ITEM NO.: 3

FILE NO.: S-867-R(10)

NAME: Chenal Valley Phase 37 – Preliminary Plat

Master Street Plan for S-867-R(10)

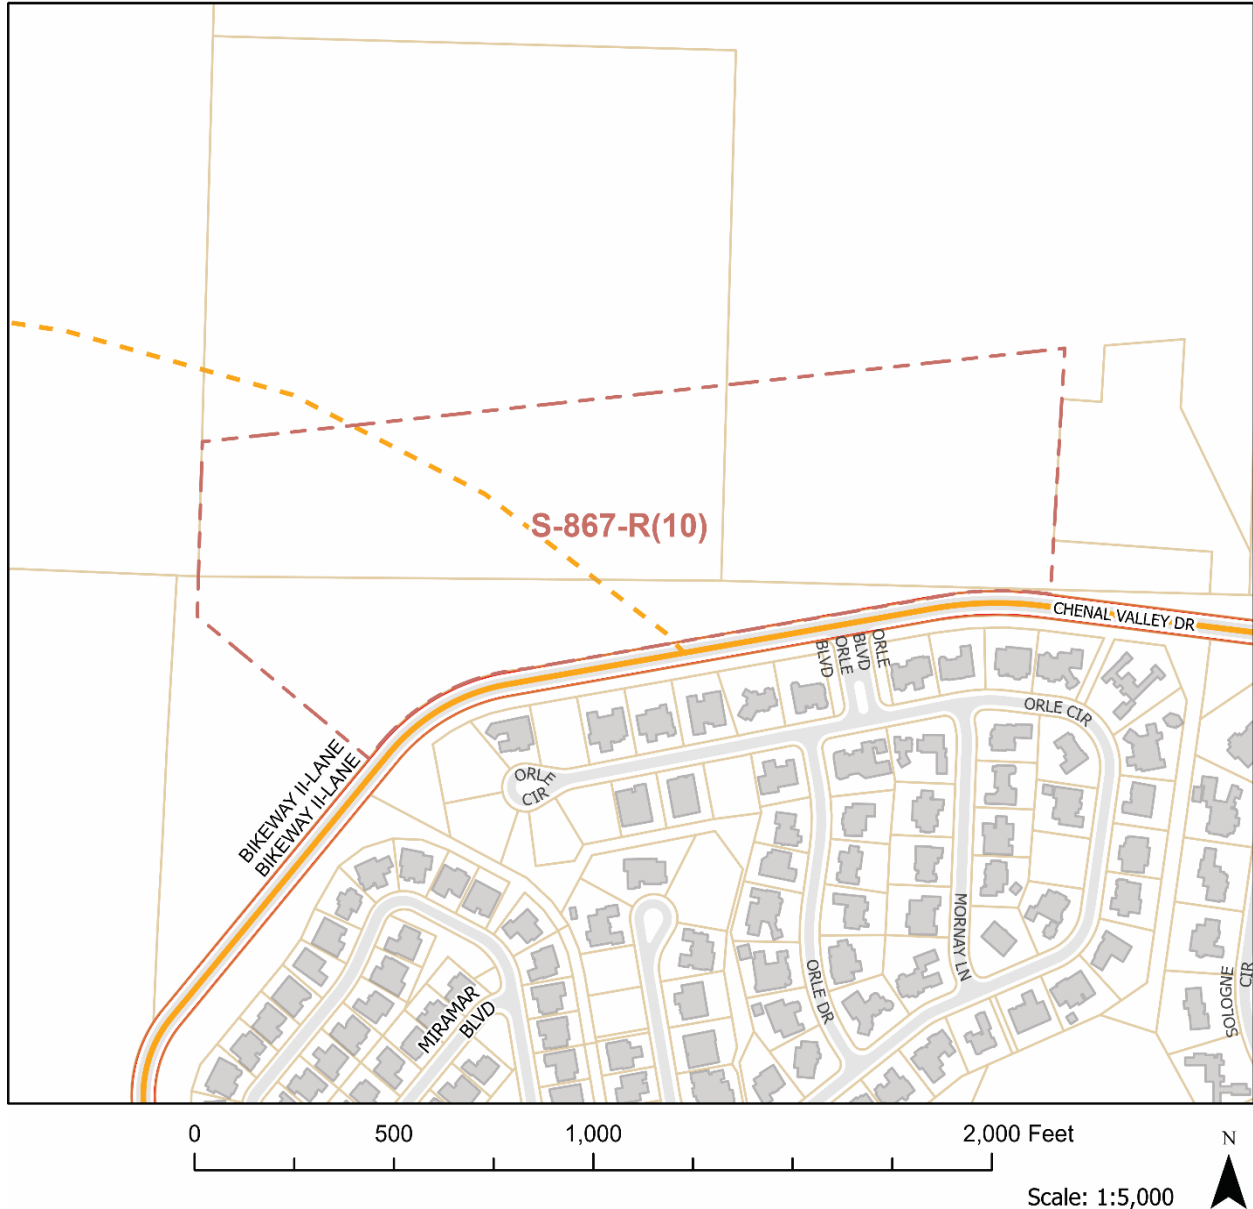
Chenal Valley Drive is a Collector on the Master Street Plan. Collectors are designed to connect traffic from Local Streets to Arterials or to activity centers, with the secondary function of providing access to adjoining property. The standard Right of way is 60'. Sidewalks are required on one side of Collectors. This street may require dedication of right-of-way and may require street improvements.
